LANDSCAPE CALCULATIONS

MEADOWBROOK COLORADO SPRING, (

L1.0

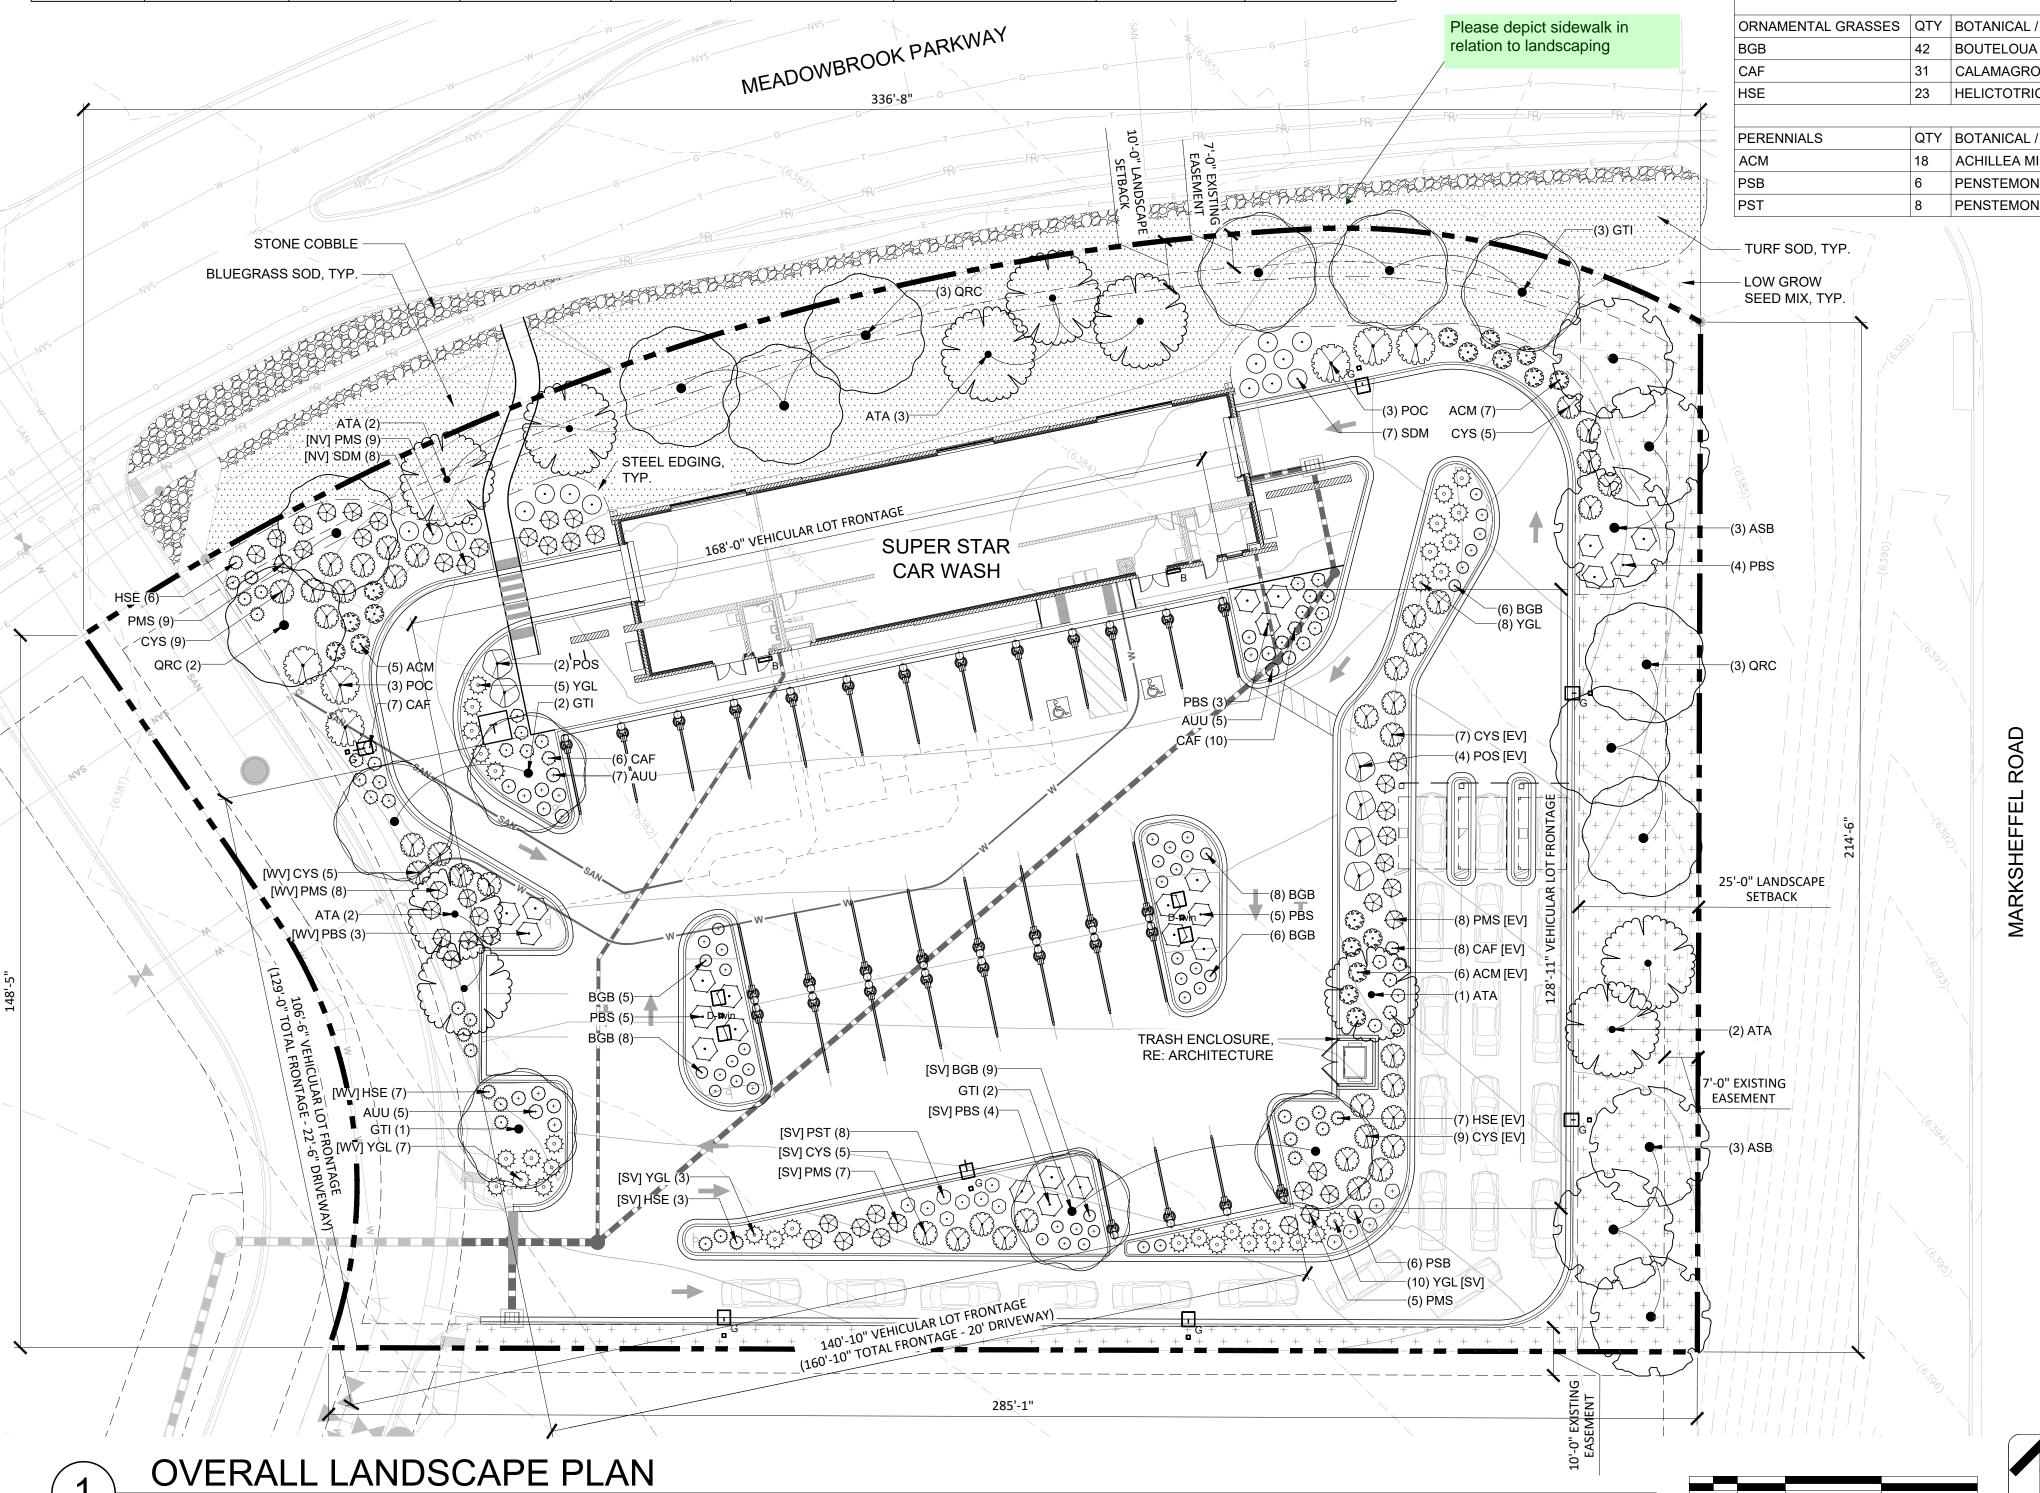
plants? if so, show where, if requesting an alternative landscape plan please title this as so and explain the justification in the letter of intent

- existing zoning of all surrounding properties

- sight distance triangle for where customers enter and exit the property in relation to landscape setback and

show how landscaping in NOT within the triangle
